**TOWN OF CARMEL**  
**PLANNING BOARD**

**PLANNING BOARD AGENDA**  
**APRIL 27, 2022 – 7:00 P.M.**

- "Plan Addressing Public Hearing Comments – Western Bluff Subdivision" (Sheet 10/10), prepared by Kellard Sessions Consulting, dated (last revised) April 12, 2022

**S-1**

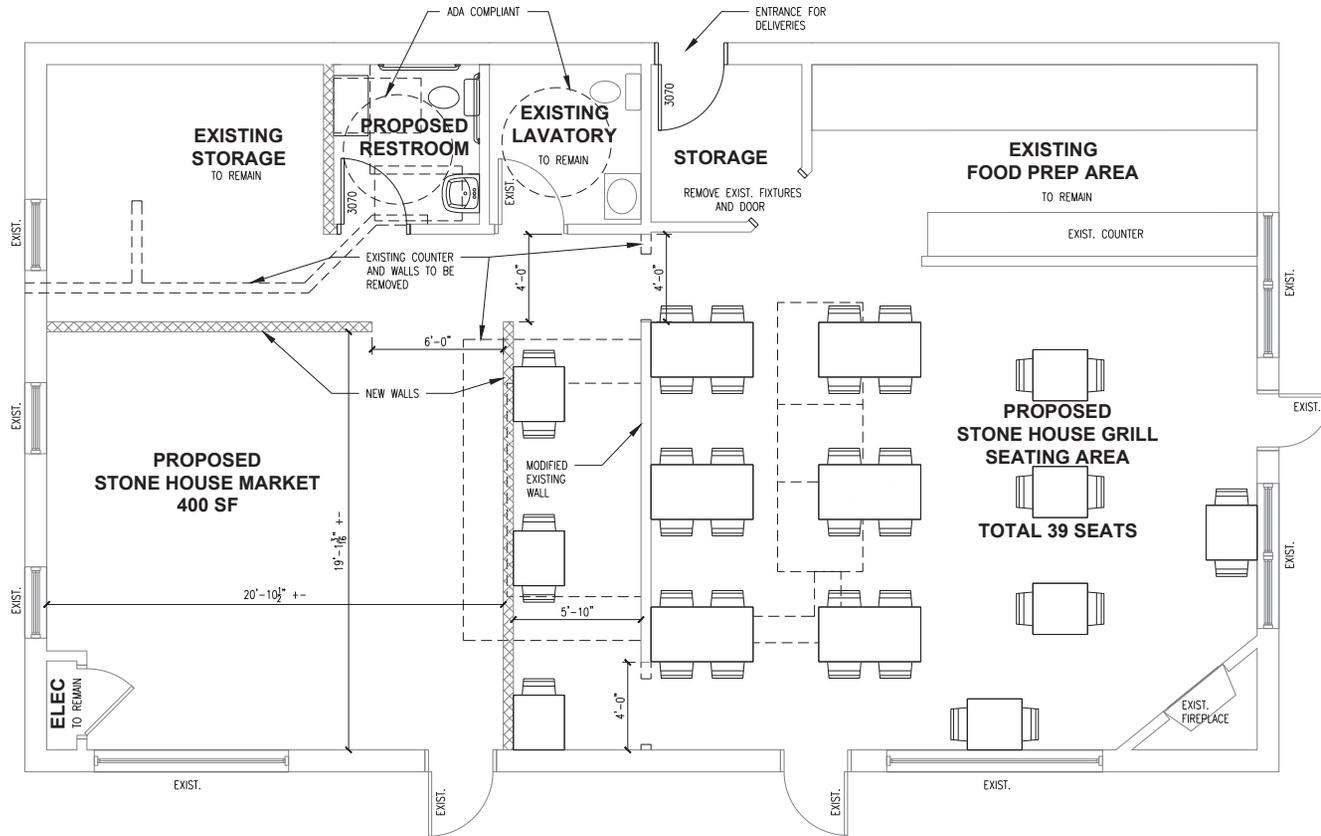
The following is my response to the Building Inspector's memo dated 4/12/22

The following is my response to the Town Planner's memo dated 4/14/22

The following is my response to the Town Engineers memo dated 4/6/22

1. The rear wall of the building is shown on the Site Plan.
2. All the required variances were approved by the Zoning Board on 9/2/08.
3. The storage units were used by the previous tenant and will be removed from the Site Plan.
4. The outdoor dining was addressed on the Site Plan submitted. It states that the total number of seats will be 39 i.e. during the summer months any outdoor dining tables will be subtracted from the indoor tables so that the total number of seats will never exceed 39.
5. The existing and proposed bathrooms are handicap accessible
6. The sign details have been added to the Site Plan.
7. The existing trash enclosure/dumpster is shown on the Site Plan.
8. Deliveries will be made from the existing driveway where the trash enclosure/dumpster are located.
9. No new variances are required.

1. As per the Floor Plan, the market is affiliated with the restaurant and will sell goods made in the restaurant.
2. Permanent outdoor seating is not proposed for the patio. See explanation in comment number 4 above.
3. The number of tables and seats in the restaurant is correct.
4. Variances indicated on the zoning chart were approved by the Zoning Board 9/2/08.
5. The storage containers behind the building were used by the previous tenant and will be removed.
6. See number 8 above regarding deliveries.
7. The building façade signage and lighting will not change. The only modification is to add a second sign on the building matching the size and

materials of the existing sign and will indicate, "Stone House Market." See elevations on Site Plan.

8. The existing planting on the site will remain as is. No modifications are proposed.
9. No irrigation is proposed.
10. The outdoor lighting for the patio is shown on the Site Plan. No changes are proposed.
11. No modifications to the existing curbing are proposed. Therefore, no NYSDOT approval is required.
12. Since no modification to the curb cuts are proposed, no changes to the onsite parking are necessary.

1. Since no changes are proposed in the NYSDOT ROW, their approval is not required.
2. If required, PCDOH approval will be obtained.
3. The Site Plan indicates all the existing conditions. No site work is proposed.

4. No new storm water lines are proposed.
5. The monitoring wells were terminated many years ago.
6. Graphic representation of vehicle movements are shown on the Site Plan.

7. The site distance at the curb cuts was approved by the Planning Board in 2008.
8. No clearing along the edge of the roadway is necessary since no obstructions regarding site distance exists.

9. The slope of the entire site is approximately two percent.
10. No work is proposed in the NYSDOT ROW.
11. Pavement markings and directional arrows are shown on the site plan.

12. A construction sequence is not required since no work is proposed.
13. All the existing trees and landscape are to remain. Tree protection is not required since there is no site work proposed.

14. All utilities are shown.
15. A water/wastewater report will be submitted.
